Meeting Minutes from December 5, 2016 Design Workshop

OhioHealth SR 315 Interchange Improvements (PID 103970) Design Workshop

Date: December 5, 2016

Preliminary Study Alternative – 45mph (full concept)

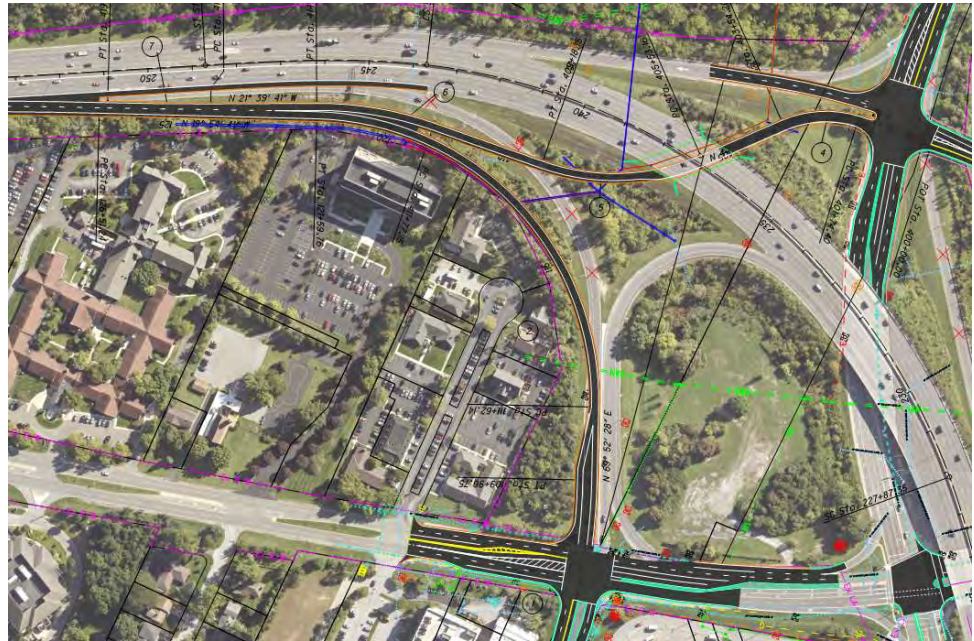
- Preliminary Study Alternative – 45mph
 - This was the alternative that was developed back in January. The design was developed at that time with only enough engineering to determine if the concept was feasible and to determine if there are any red flags.

- The alternative utilizes a 2,500' length of pacing prior to the exit gore along SR 315 SB and utilizes a 2-lane diverge for the ramp from SR 315.
 - Past the diverge from SR 315 SB, the 2-lane ramp splits to a single lane going to North Broadway and a single lane going to Olentangy River Road/Thomas Lane

- The proposed SR 315 SB to Olentangy River Road/Thomas Lane ramp meets 45-mph design criteria
 - The proposed SR 315 SB to North Broadway ramp meets 45-mph criteria for the first horizontal curve (in the exit gore of the two ramps) then steps down to a 40-mph curve and finally a 30-mph curve as it approaches North Broadway's intersection.

- Since OhioHealth Boulevard is likely to be posted at 25-mph, ODOT is ok with the 30-mph ramp design speed for the last horizontal curve
 - The SR 315 structure over the new North Broadway ramp is wide enough to accommodate horizontal stopping sight distance requirements that meet 40-mph design while providing 2-lanes along the ramp under the bridge.

- All alternatives assume meeting 15'-6" vertical clearance requirements for SR 315 over the new ramp
 - ODOT finds this value acceptable

Braid Alternative

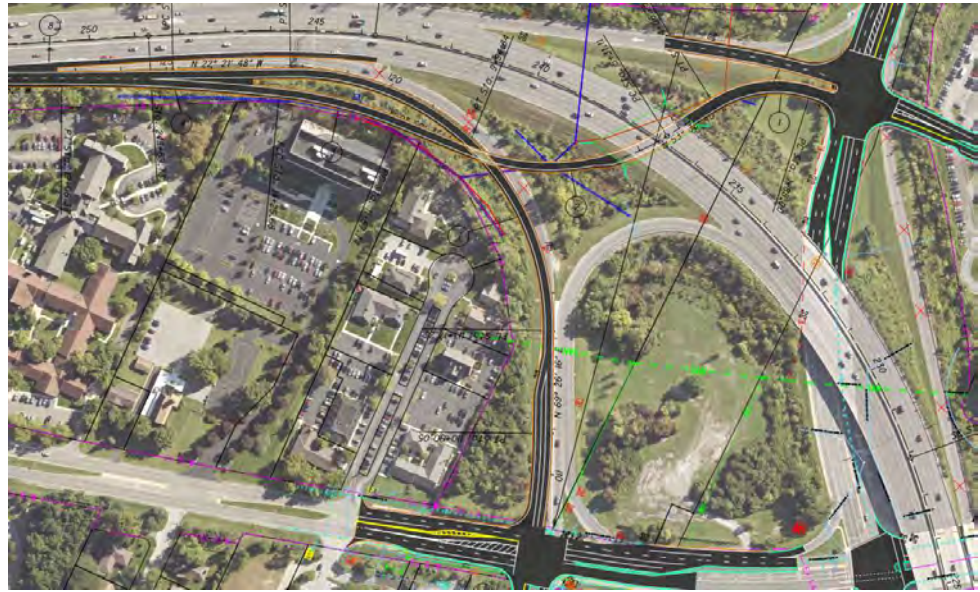
- This alternative braids the proposed North Broadway ramp underneath the proposed ramp to Olentangy River Road/Thomas Lane.
- The goal of this concept was to reduce the R/W impacts in the northwest quadrant of the interchange adjacent to the Olentangy River Road/Thomas Lane ramp

- If the design keeps the Olentangy River Road/Thomas Lane ramp near the existing elevation then the North Broadway ramp is in a deep cut, which will cause problems for the new drainage ditch to be placed on the west side of the ramp as well as the impacts to the adjacent properties north of the ramp crossing point.

- One option is to raise the proposed Olentangy River Road/Thomas Lane ramp so that the new North Broadway ramp doesn't have to be in as much cut; however, this creates a constructability issue with trying to construct the new ramp adjacent to the existing ramp at different elevations while maintaining the existing ramp to the hospital.

- Significant design and constructability concerns with the new braid structure due to the skew and the close proximity to the existing ramp pavement
- *It was decided at the workshop that this alternative wasn't an ideal solution and as such the Design Team isn't anticipating to carry this alternative forward for further consideration.*

Flyover Alternative

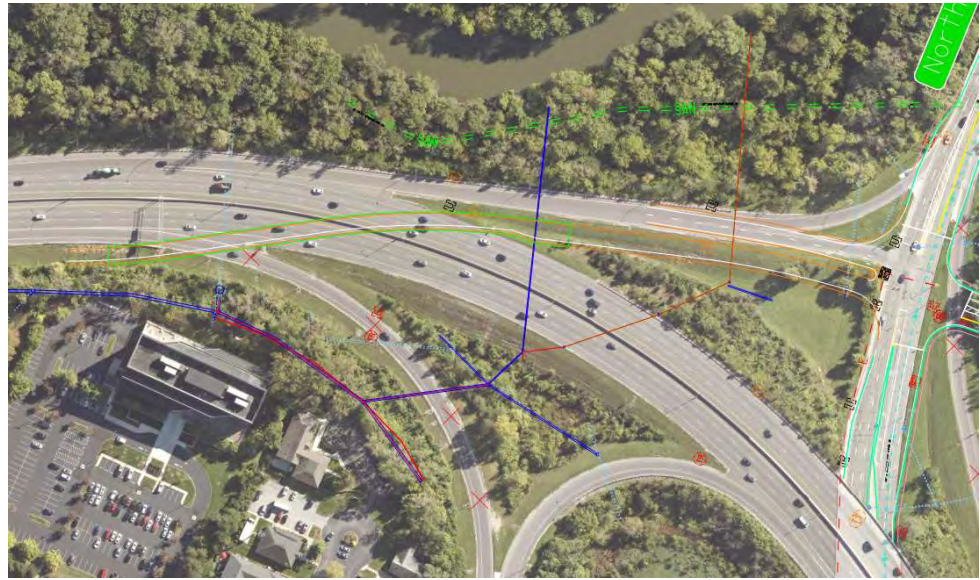
- This alternative was designed to carry the proposed North Broadway ramp over SR 315 instead of under as in the other alternatives
- This alternative was developed by the Design Team only far enough to determine what the profile of the flyover ramp over SR 315 would be

- The resulting vertical grade of the North Broadway ramp to get over SR 315 and then connect to the existing North Broadway at an intersection is -7% that goes right to North Broadway without any flatter grade within the intersection area; the design speed of the ramp is 30-mph.

- There is a concern that in snow and ice conditions, this ramp geometry won't allow vehicles to stop as they approach the intersection or the back of queue from the signal

- *It was decided at the workshop that this alternative wasn't an ideal solution and as such the Design Team isn't anticipating to carry this alternative forward for further consideration.*

Preliminary Study Alternative – 40mph

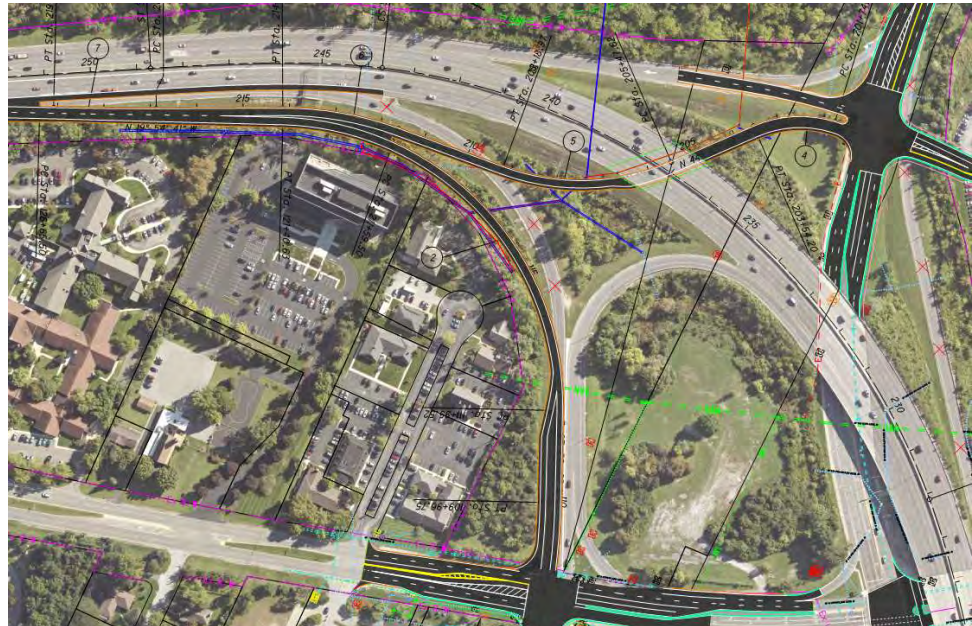
- This alternative revisited the *Feasibility Study* alternative and made one modification. This alternative utilizes a design speed of 40-mph for the proposed SR 315 SB to Olentangy River Road/Thomas Lane ramp.
- The existing ramp meets 30-mph design criteria; the proposed ramp will have a higher design speed even at 40-mph (instead of 45-mph as shown in the Feasibility Study alternative) and will provide greater deceleration length than the existing condition which should make this a better solution than the existing.
 - ODOT is ok with the 40-mph design speed for this ramp since it is along a similar alignment to the existing
- *ODOT agreed that the use of 40-mph design criteria for the Olentangy River Road/Thomas Lane ramp is acceptable*

Preliminary Study Alternative – Shortened Exit

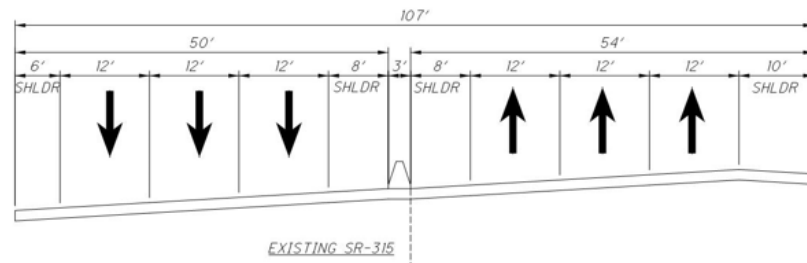
- This alternative revisited the *Preliminary Study – 40mph* alternative and made one modification. This alternative utilizes a single lane exit diverge from SR 315 SB for the two proposed ramps.

- The proposed traffic expected to be using this diverge as shown in the Interchange Modification Study (IMS – submitted to ODOT for review on 12/2/16) it was determined that a single lane exit would be sufficient. As a result, the 2,500 feet length of additional lane along SR 315 SB north of the new diverge isn't needed.

- This alternative shortens the work limits and gets out of potential conflict with the ODOT Noise Wall project that is currently being developed that places a noise wall between SR 315 and Olentangy River Road north of the point where these two roadways are in tight proximity with each other

- City of Columbus wants to make sure that the sight distance to the signal is provided and that the structure isn't in the way – the Design Team will evaluate this and accommodate it in Final Design.

- The distance between ramp gores is greater than 800 feet to allow for adequate signing of the diverges for this option. This alternative closely matches the situation that is present along SR 315 NB at the diverge to Olentangy River Road and then the subsequent diverge to North Broadway.

- ODOT concurs with the gore-to-gore spacing as shown in the alternative
- The placement of the retaining wall along the proposed Olentangy River Road/Thomas Lane ramp should be such that safety grading can be achieved if possible. If guardrail must be placed in order to eliminate R/W impacts, coordinate with ODOT before moving ahead. Hold the maximum shoulder width of 12 foot paved. Turf shoulder can be used beyond the 12 foot line if the wall is farther out.

- Assuming the IMS gets approved, this alternative is the one that was believed to be the best solution of all of the presented alternatives by the participants of the workshop. This will be the alternative that the Design Team will carry forward.

Potential Overbuild Typical Sections - MOT

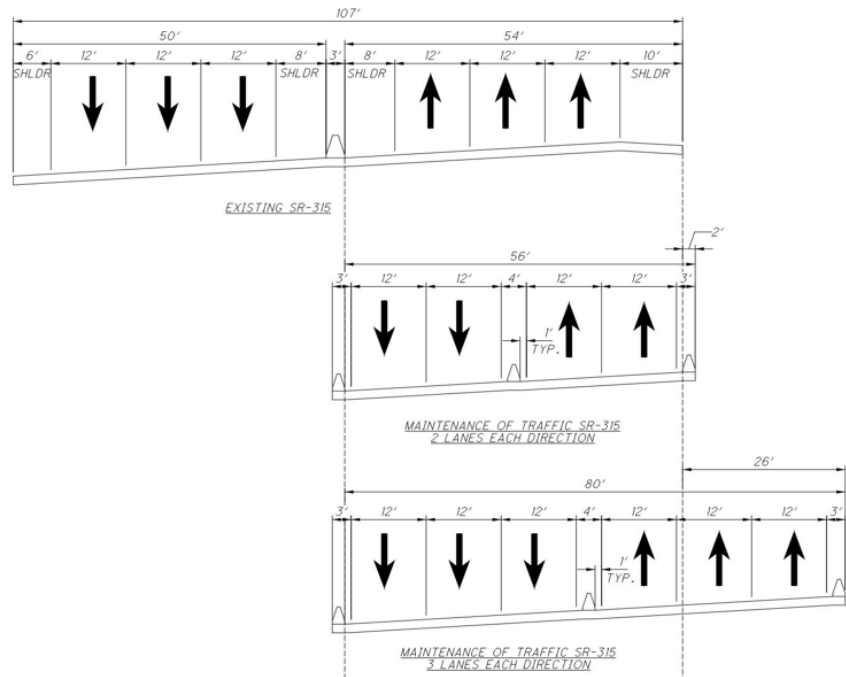
- **Overbuild Existing Alternative**
 - In order to maintain three lanes in each direction, SR 315 NB would need to be over-built by 26 feet to the east. There are several challenges with accomplishing this, including impacts to the 100-year flood plain, river impacts, impacts to the existing Broadway to SR 315 NB ramp, and construction of the parking garage that is on the proposed development site.

- Because of the inability to overbuild and widen existing SR 315 SB (due to proximity of North Broadway and the existing vertical clearance pinch that would result in overbuilding to the west) the maintenance of traffic would most likely result in a contra-flow situation in the second phase of bridge construction when the structure carrying SR 315 NB over the new ramp was constructed.

- *It was decided at the workshop that this alternative wasn't an ideal solution and as such the Design Team isn't anticipating to carry this alternative forward for further consideration.*

SR 315 SB Runaround Geometry

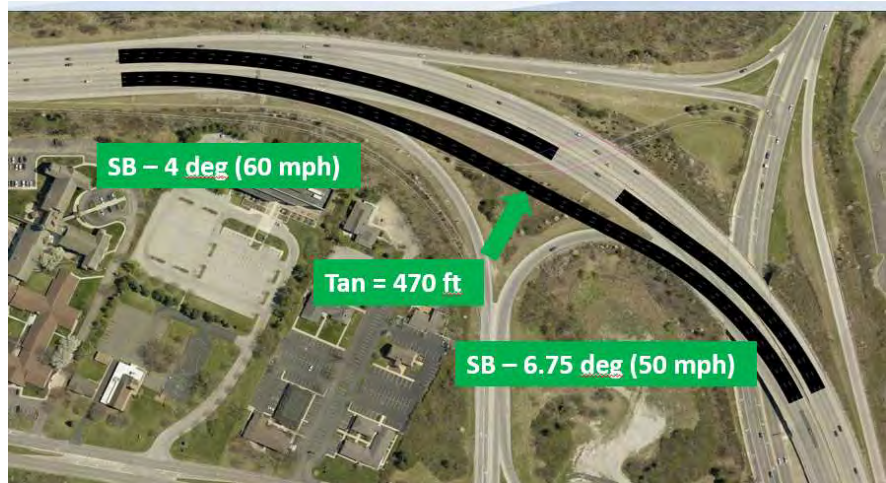
- **3-Lane Runaround Alternative – SR 315 SB only**
 - One option investigated was to pull SR 315 SB completely off of existing alignment in order to construct the new bridge in two construction phases. This would allow SR 315 NB to stay in the existing NB lanes (Phase 1) then shift over to the existing SB lanes (Phase 2).
 - For SR 315 SB Runaround, departure curve from existing SR 315 meets 60-mph design criteria, and the entering curve back onto existing SR 315 meets 50-mph design criteria.
 - For SR 315 NB when shifting to existing SB lanes, there would be several curves all going in the same direction with varying radii that the driver would have to navigate – very uncomfortable drive through the workzone.
 - Access will be hindered when constructing the proposed SB bridge over the new ramp – traffic will be on both sides of the construction zone

3-Lane Runaround – both directions of SR 315

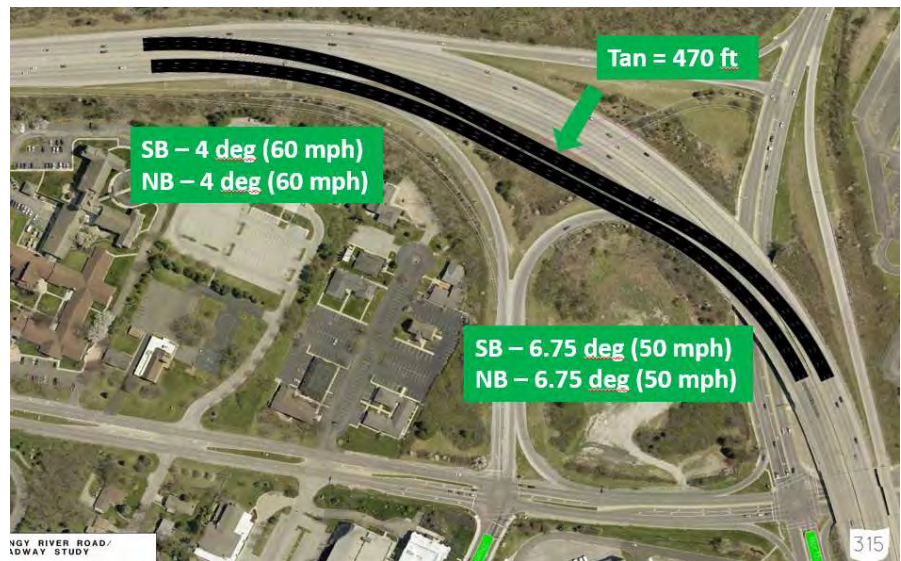
- **3-Lane Runaround Alternative – SR 315 NB and SR 315 SB**
 - Another option investigated was to pull both directions of SR 315 off of existing alignment in order to construct the new bridge in one construction phase.
 - Simplified geometric alignments through the workzone, and easier construction method should be realized for the proposed bridge. Expectation is that the bridge construction will be the quickest construction in this option, but will be offset by the need to construct the runaround prior to bridge construction.
